NORTHWEST HILLS REGIONAL ANIMAL FACILITY

S/P+A PROJECT NO. 17.105

DATE: May 7, 2021

The following changes to the Drawings and Project Specifications shall become a part of the Drawings and Project Specifications; superseding previously issued Drawings and Project Specifications to the extent modified by Addendum No. 2.

DOG RUN HATCH DOOR DTL. "2"
SCALE: 1/2" = 1'-0"

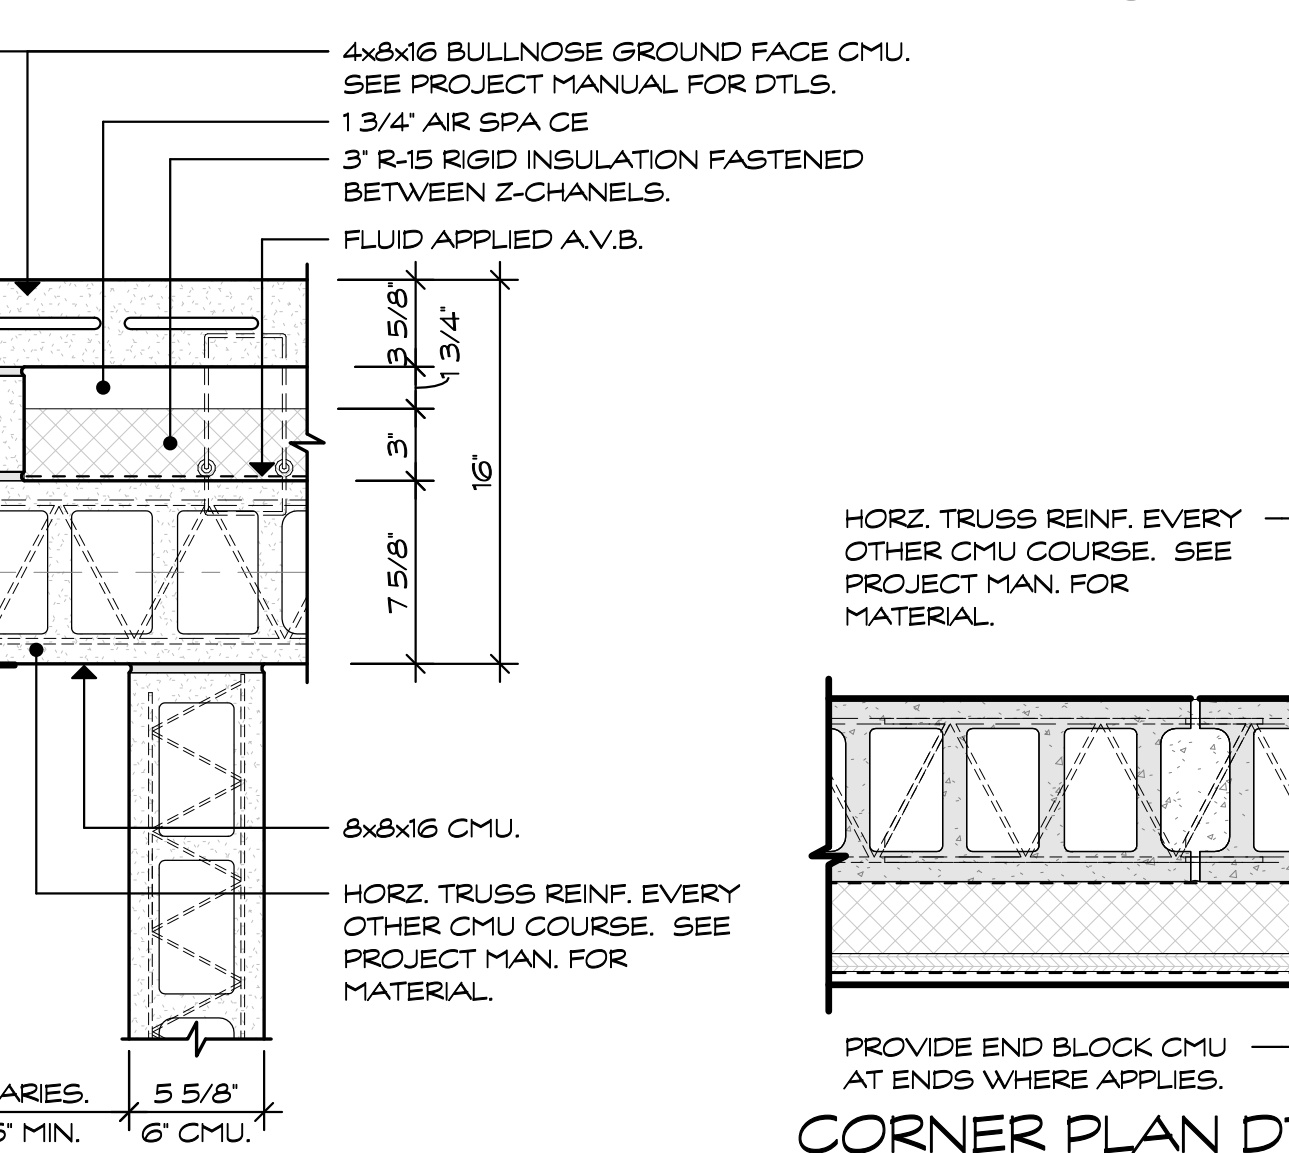
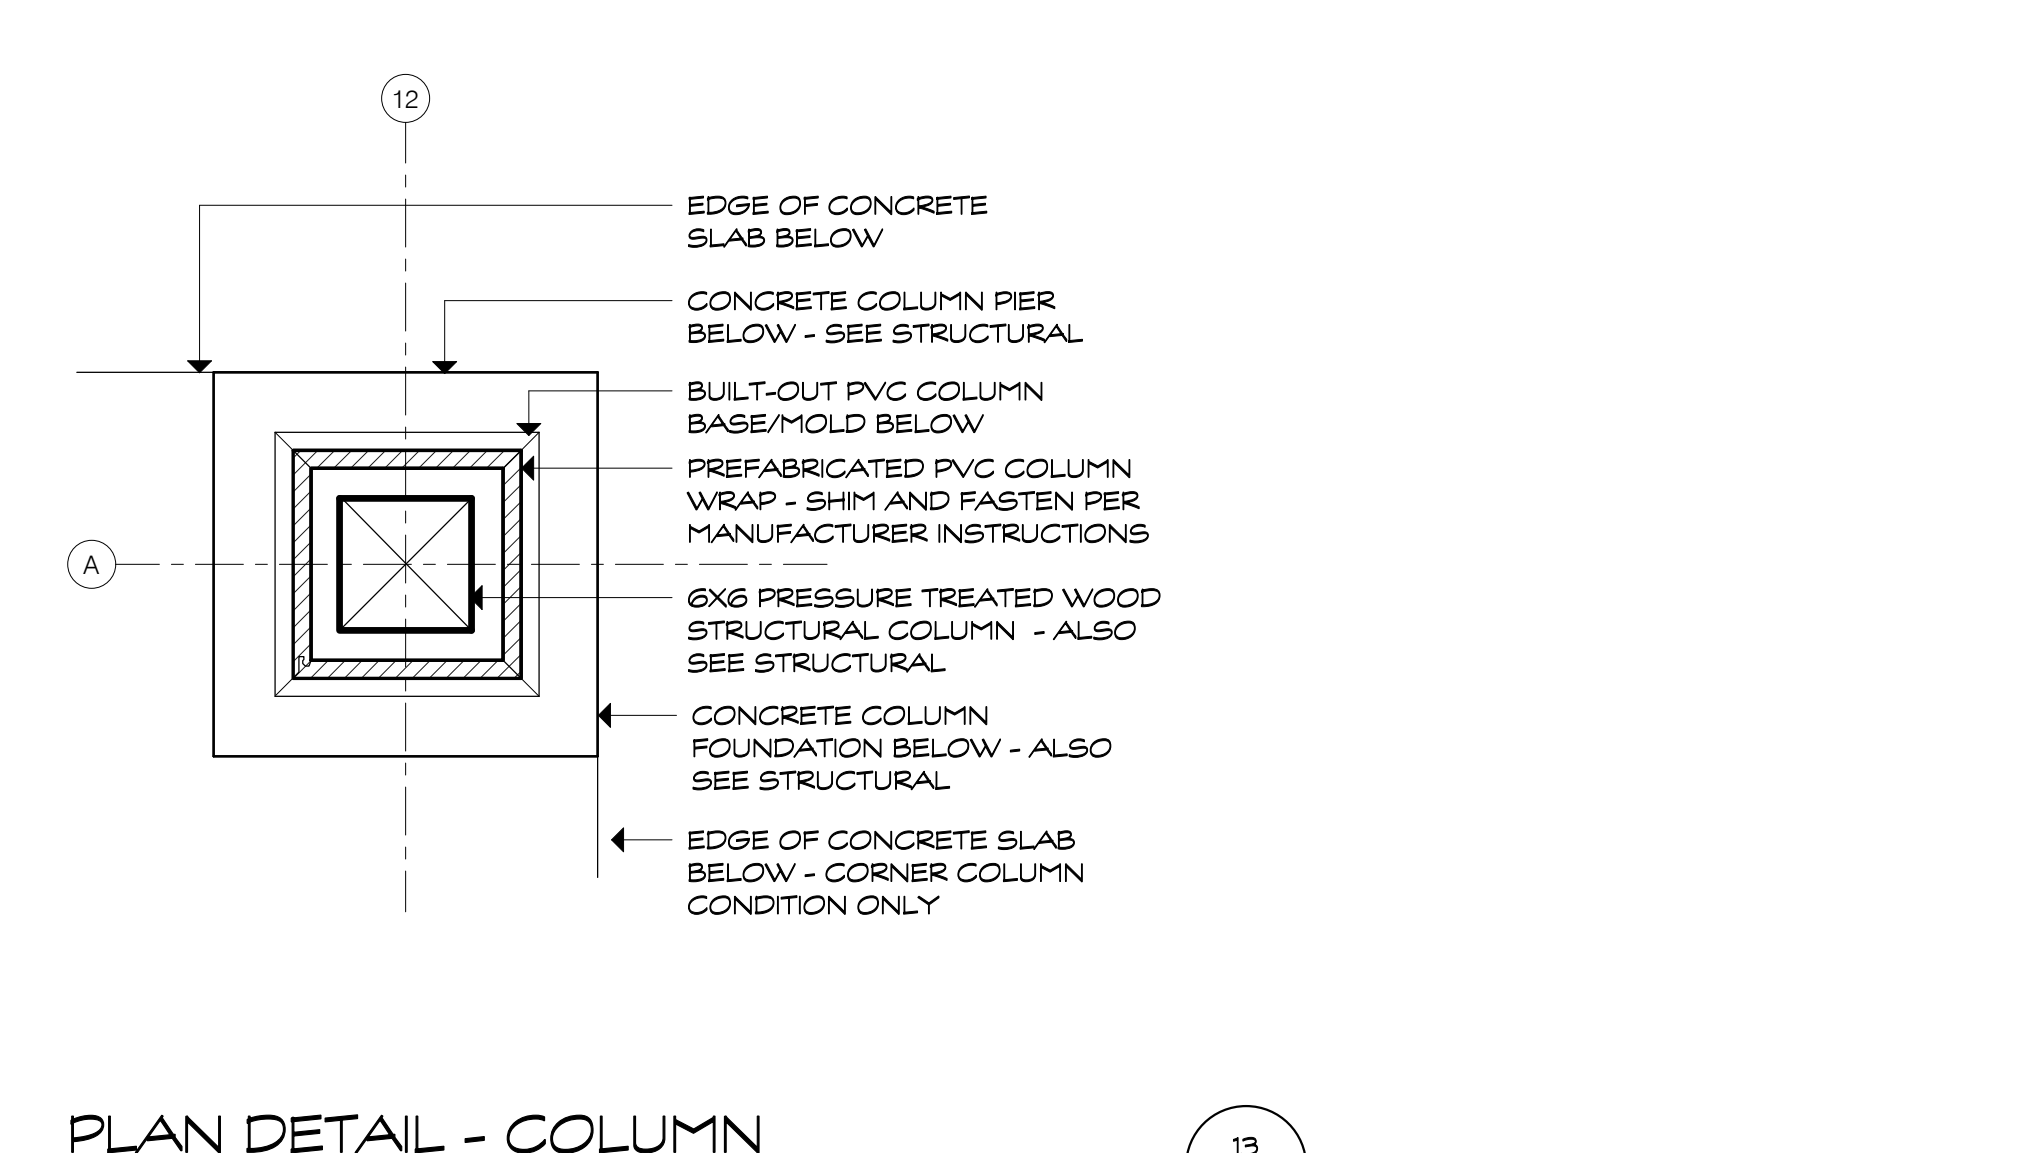
Revision:	Description:	Date:	Revised By:
BID SUBMISSION		04/16/2021	
1	DOG-RUN/FENCE UPDATE	05/07/21	BV
